Subject: Notification of Class 1 Permit Modification Updates Associated with the Technical Area 63 Transuranic Waste Facility Container Storage Unit of the Los Alamos National Laboratory (LANL) Hazardous Waste Facility Permit, EPA ID # NM0890010515

Enclosures: (1) Class 1 Permit Modification Notification Updates for the Technical Area 63 Transuranic Waste Facility Container Storage Unit, Los Alamos National Laboratory Hazardous Waste Facility Permit

Class 1 Permit Modification
Notification Updates for the
Technical Area 63 Transuranic Waste Facility
Container Storage Unit,
Los Alamos National Laboratory
Hazardous Waste Facility Permit

Figure 14: Retention Basin Depth Change

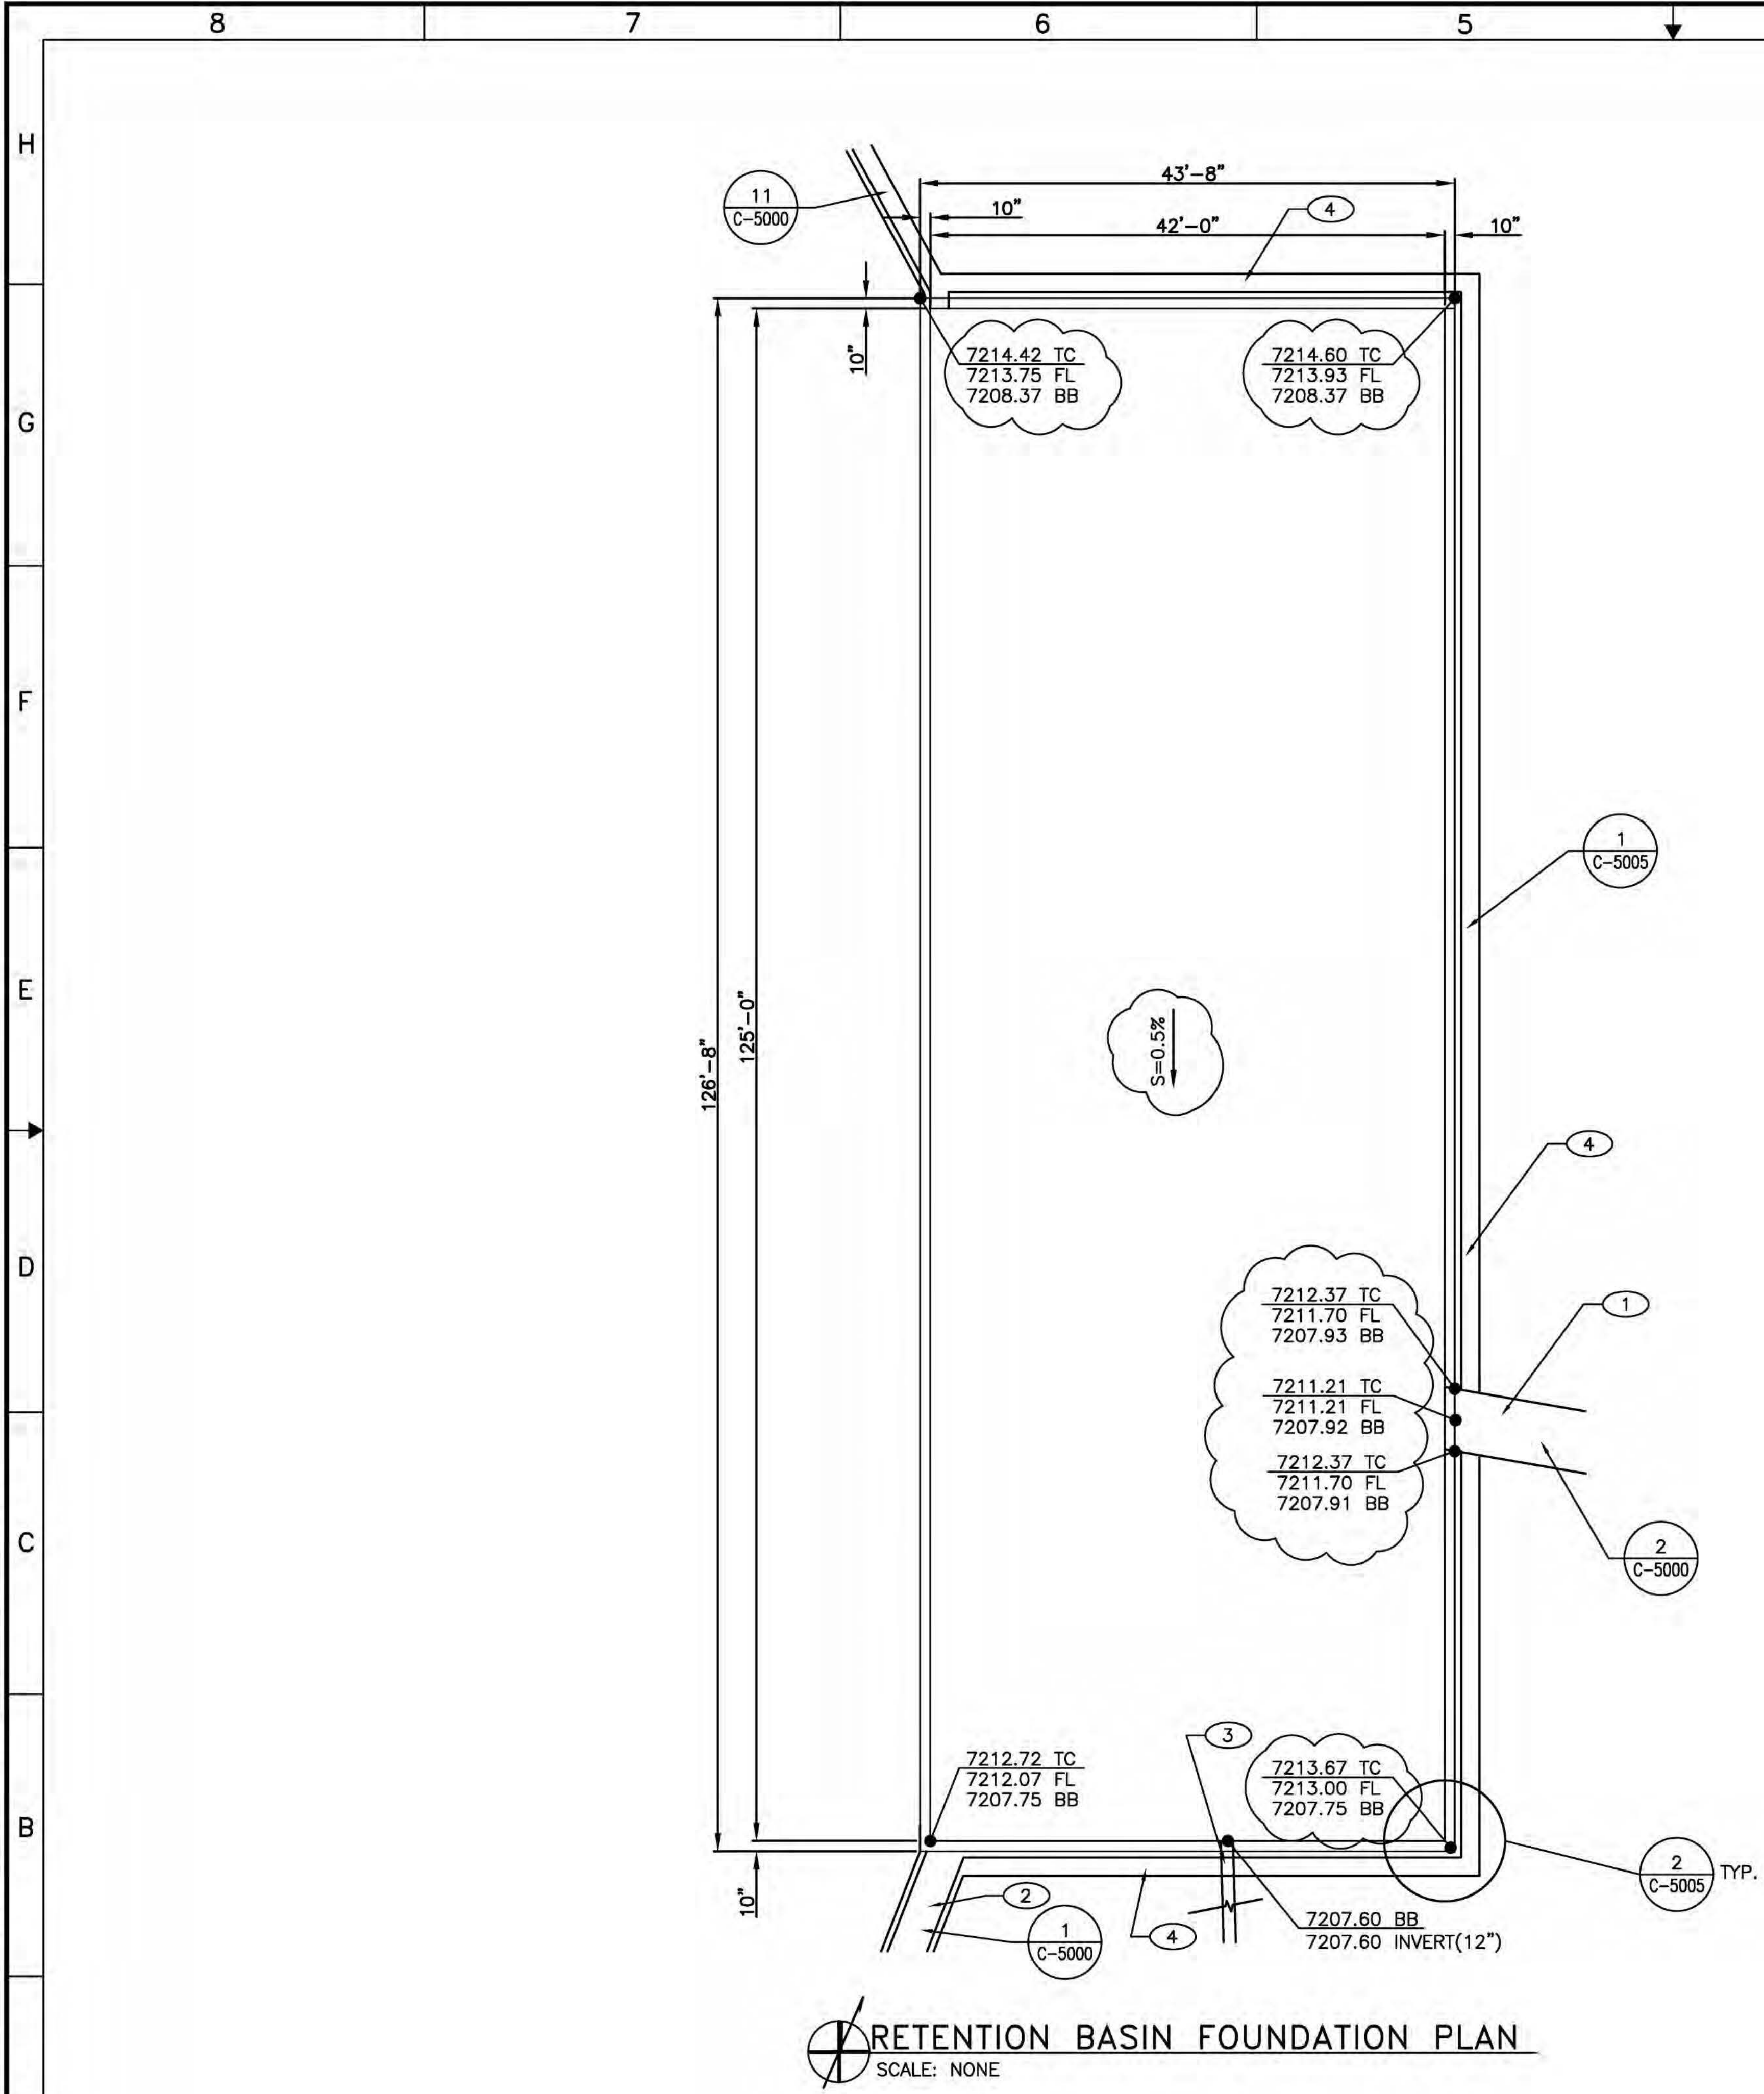
There has been a minor design change to the TWF retention basin. The retention basin is designed to collect storm water or snow melt run-off from the concrete pavement via the slope of the concrete pad. In the event of a fire at the unit, the retention basin is also designed to collect fire suppression water that could flow out of the storage buildings or from other unit structures to the concrete pad. The design change is limited to the bottom of the retention basin only and involves a change to the contour in order to improve the removal of collected water and increase

the designed freeboard for the basin walls. The original slope of the retention basin has been decreased from 2% to 0.5%. The total basin depth will change from 3.5 feet to 5.5 feet but the design volume capacity of the basin (137,450 gallons) will remain the same. The modified design detail is included in Figure 14 of Attachment 1 in this document.

This design change affects one section of the approved Permit in Attachment A, Permit Section A.6.5, *Retention Basin*, page 42, which describes the dimensions of the retention basin to be 125 ft by 42 ft by 3.5 ft deep. The sentence has been modified to provide a better description of the retention basin by substituting a depth of 5.5 ft (*see* Attachment 4).

FIGURE 55.

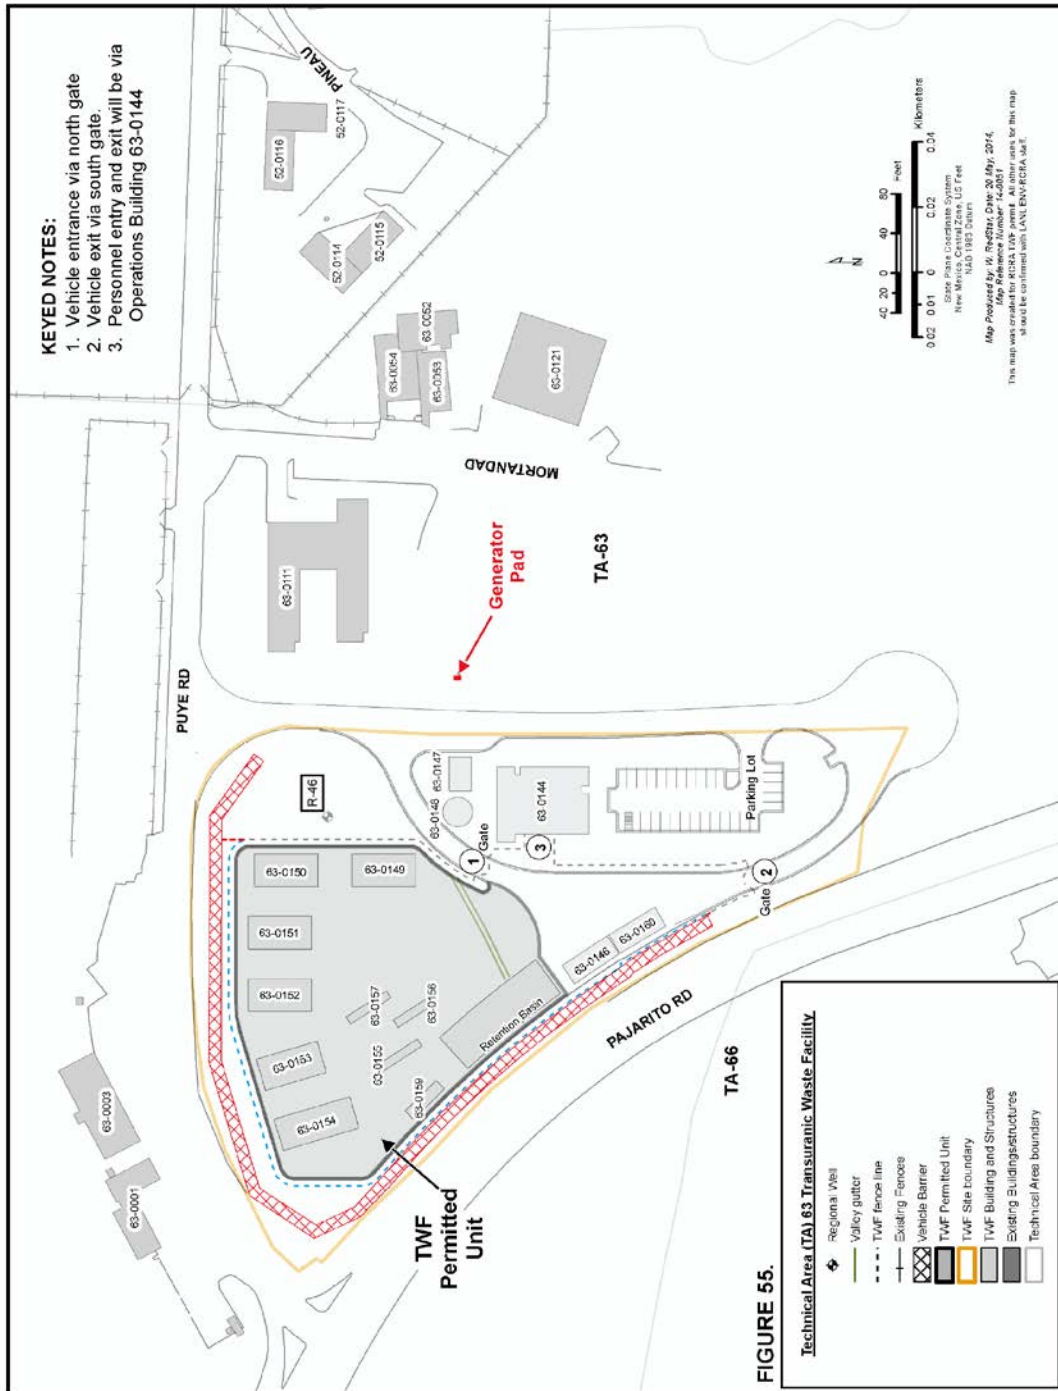
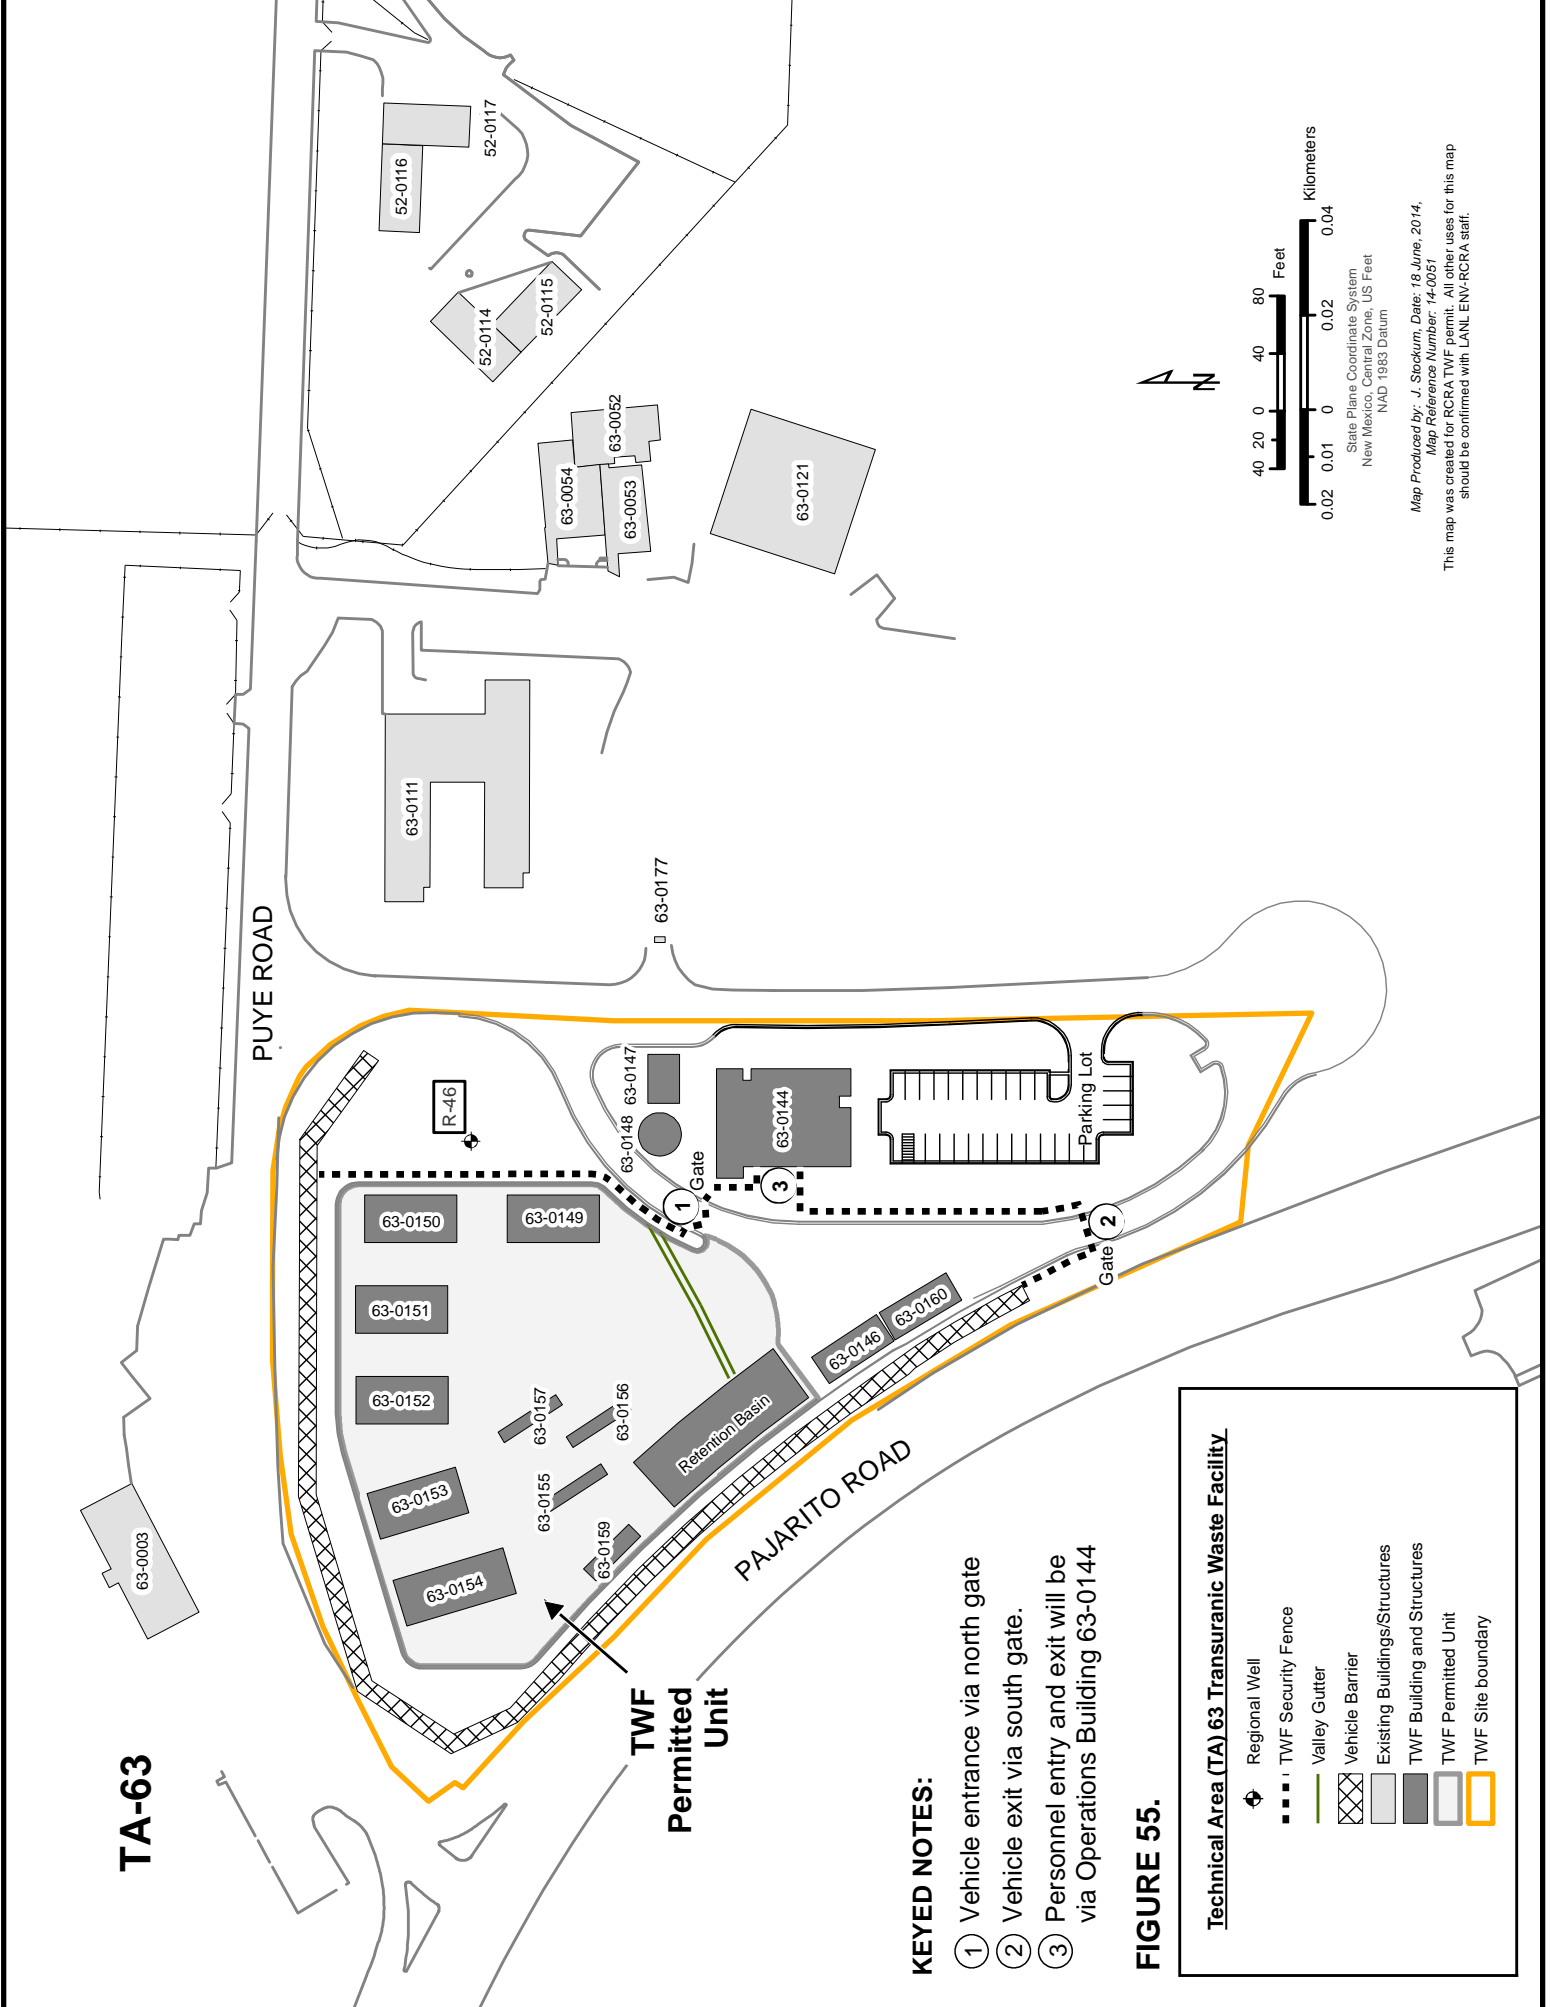
This design change affects only one portion of the approved Permit in Permit Attachment N, Figure 55, *Technical Area (TA) 63 Transuranic Waste Facility*. The figure has been modified to

As depicted in the TWF PMR and Figure 55 of the Permit, the TWF security fence was previously shown immediately surrounding the permitted storage unit on the east, north, and west sides. As part of this permit modification notification, the position of the security fence surrounding the TWF has been partially altered to incorporate the line of the Metalith™ vehicle barriers rather than running near the boundary of the permitted unit on the sides facing the Puye and Pajarito Roads. The change has been made to improve the ability of the fence to provide protection from the entry of personnel and livestock by increasing the distance from the boundary of the permitted unit and to coordinate with and utilize the increased height of the vehicle barriers on the affected sides.

The structures and surrounding buildings at the TWF site are shown in Attachment N, *Figures*, Figure 55 of the Permit. The design of the facility has been changed to include an auxiliary power generator structure on the east side of the facility and across the road from the Operations Support Building.

Attachment N, Figure 55, <i>Technical Area (TA) 63 Transuranic Waste Facility</i>	Replacement of security fence configuration.	A.1	The permit figure has been revised to provide updated information for structures surrounding the permitted unit.
Attachment A, <i>Unit Descriptions</i> , Section A.6.5, <i>Retention Basin</i>	Replacement of retention basin design depth	A.1	The change is needed in the facility description to provide information regarding the design change affecting the final design depth of the retention basin. The facility description is the only text portion of the Permit affected.
Attachment A, <i>Unit Descriptions</i> , Section A.6.6, <i>Other Project Structures</i>	Addition of generator structure	A.1	The change is needed in the facility description to provide updated information for structures surrounding the permitted unit.
Attachment N, Figure 55, <i>Technical Area (TA) 63 Transuranic Waste Facility</i>	Addition of generator structure	A.1	The permit figure has been revised to provide updated information for structures surrounding the permitted unit.

(Note: Additions shown in red, removals in blue)
